Agenda Item #4

Application 2026-6-CA

Replace windows and siding on the northeast 1929 addition.

PROJECT Window replacement

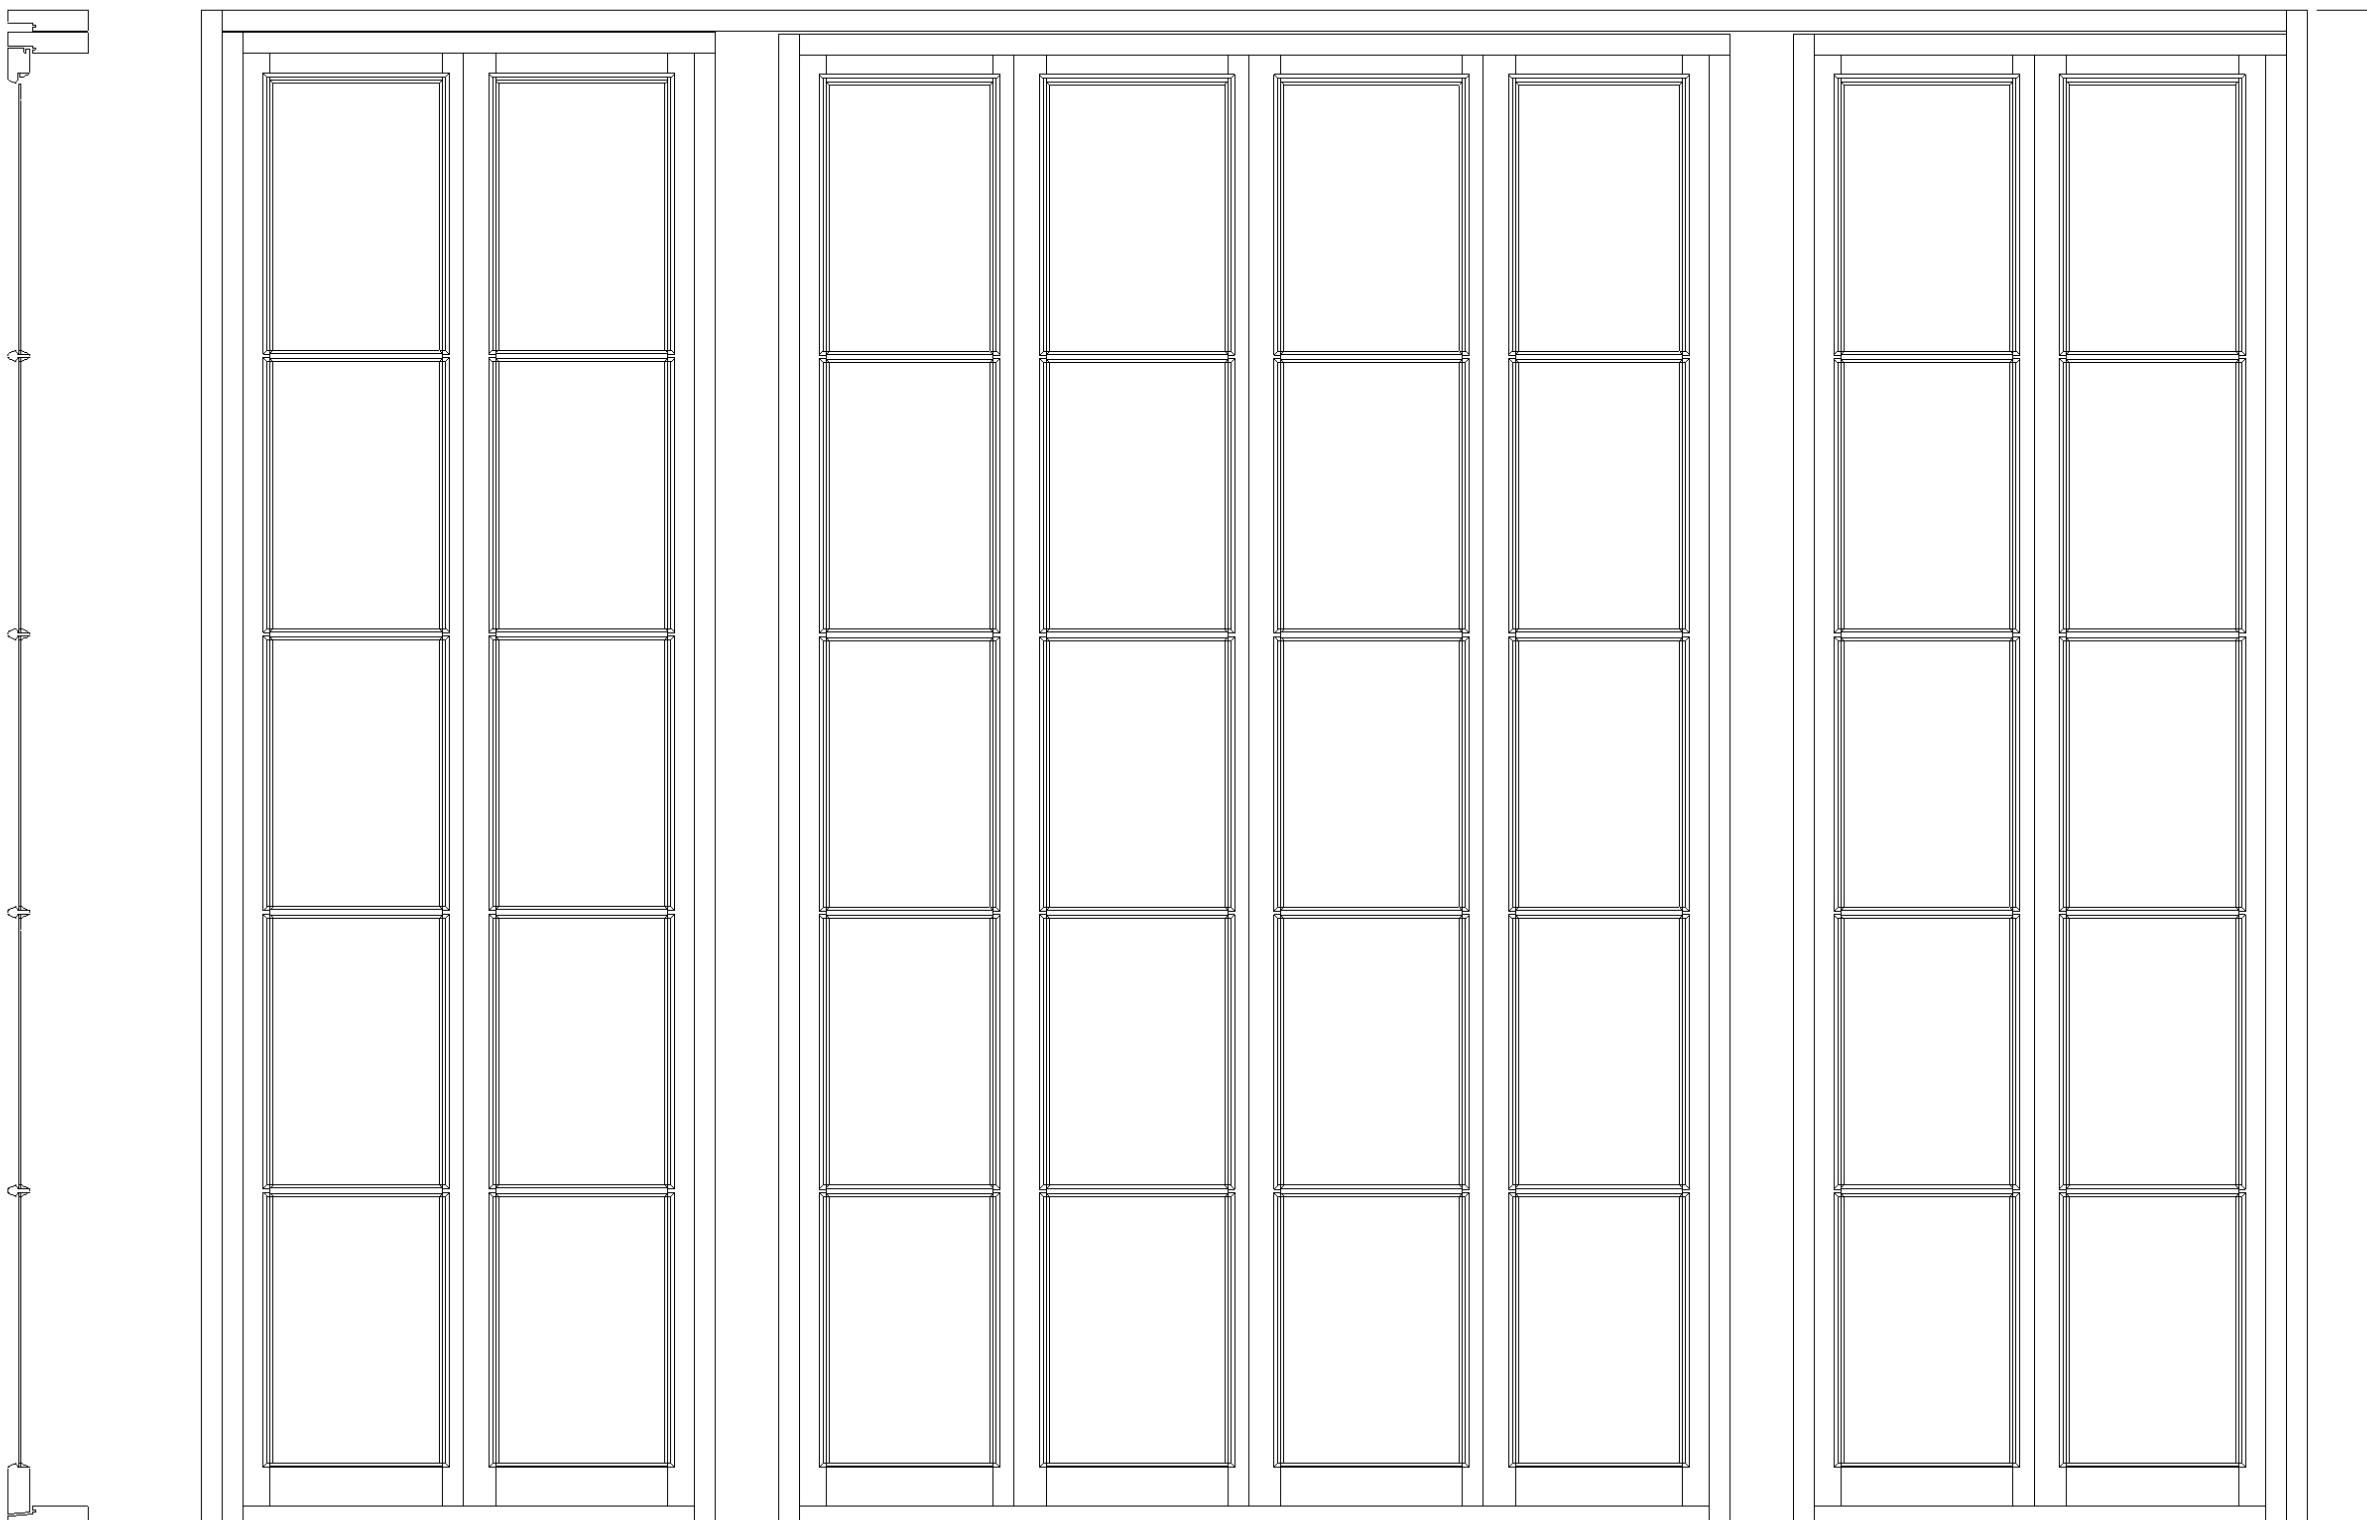
The applicant completed a window survey, assessing the condition of the windows intended for replacement on the 1929 addition at 7. N Claiborne Street. The survey and visual inspection reveal that the existing windows are in a deteriorated state with significant wood rot. However, the windows do not appear to be beyond repair. The proposed wood material for the replacement windows is acceptable under the *Guidelines*. Further, the replacement windows' 10 light configuration would match that of the existing windows. (5.6, 5.7, 5.20, 5.2)

TRANSOMS
ARE
COVERED!

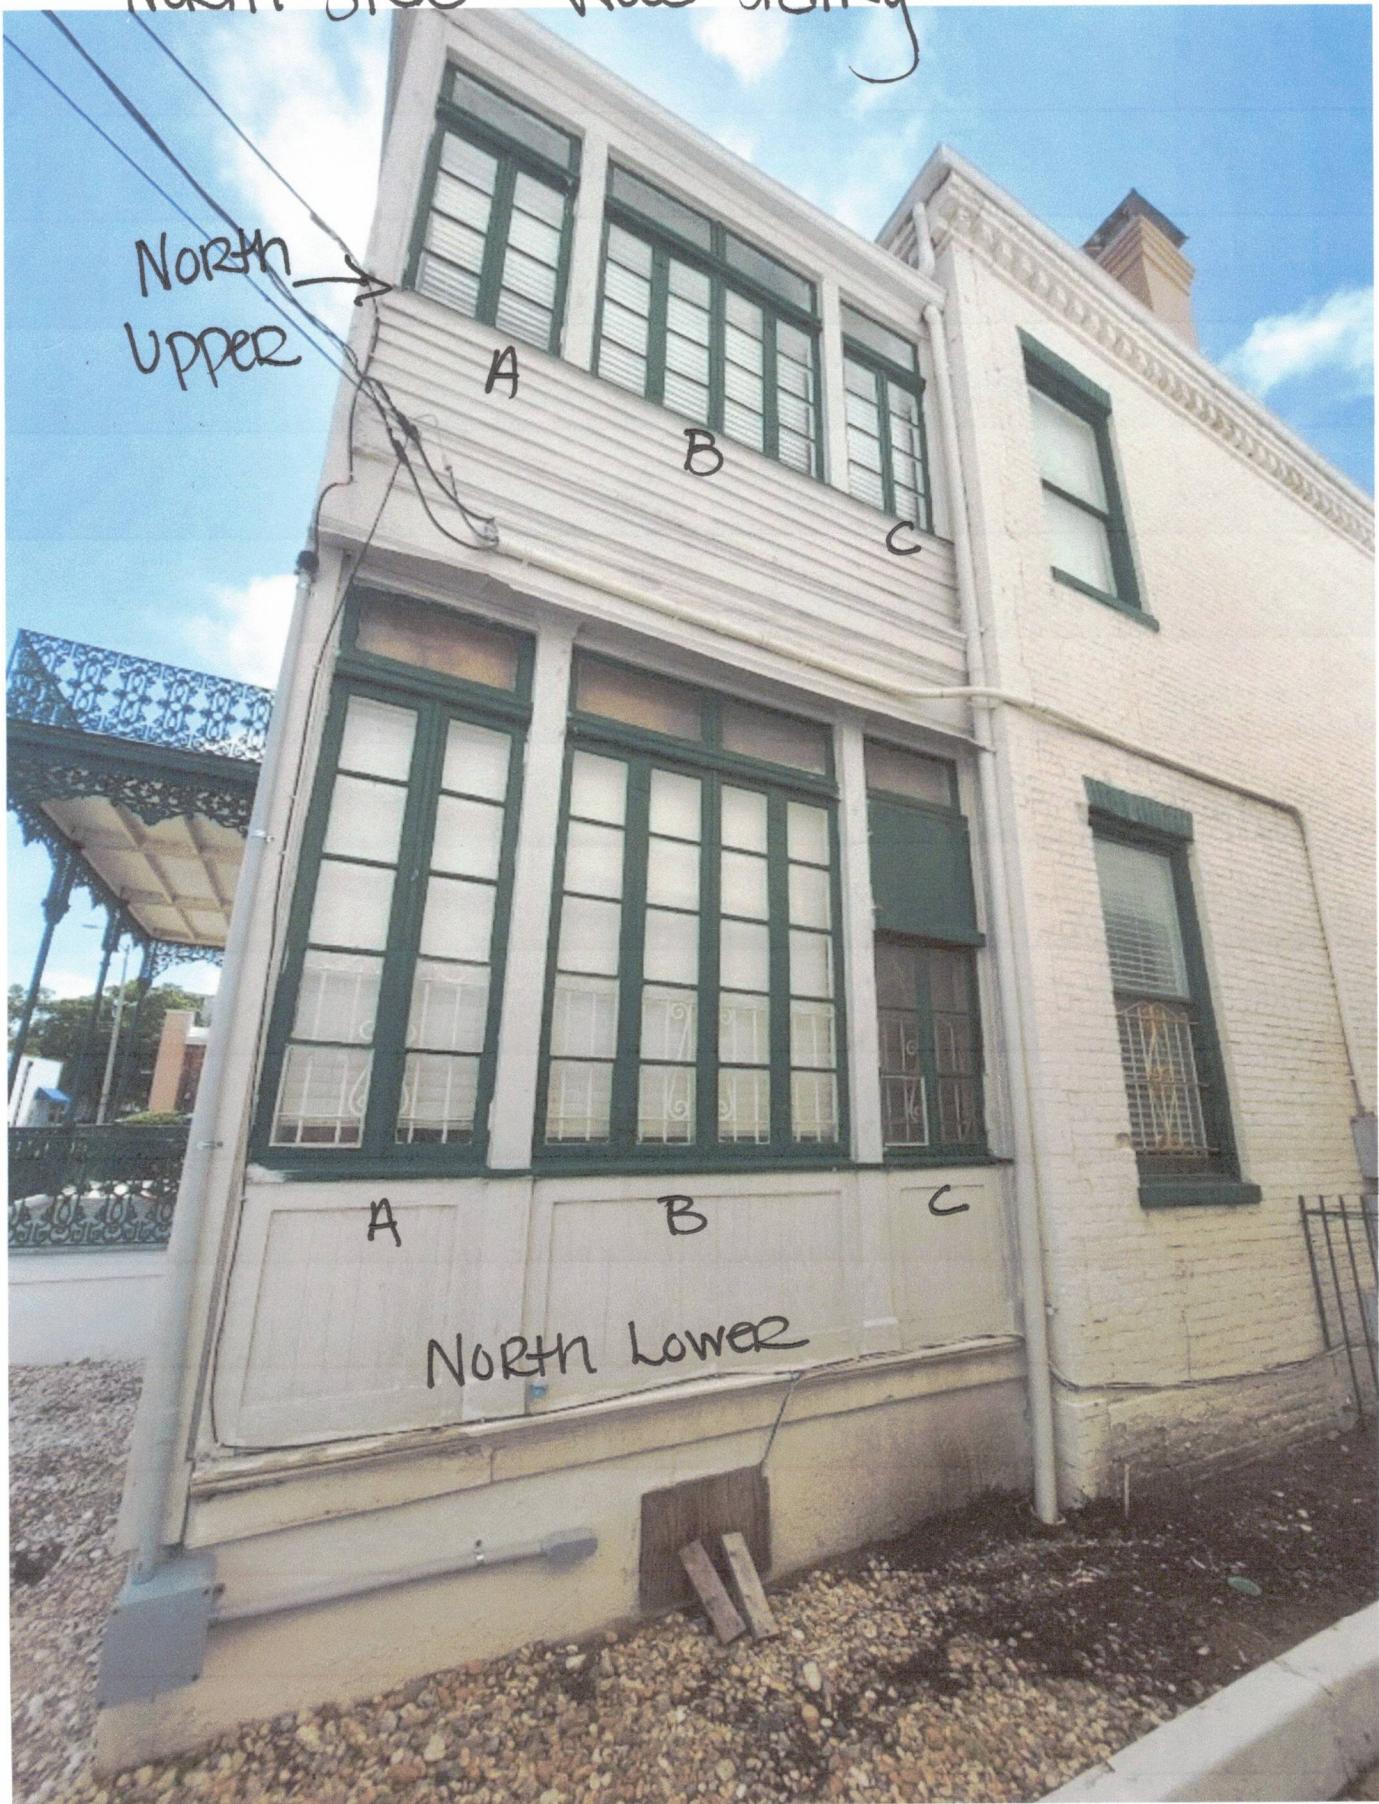
fit the existing window openings to include the removed transoms. The removal of the existing transoms is due to both cost and lack of use as the interior walls currently conceal the transoms from view from the inside of the structure.

We are requesting that all windows, upper and lower, be replaced with same size window as the current opening but without the transoms at the top. Currently the transoms are covered by a wall on the inside. See attached photo.
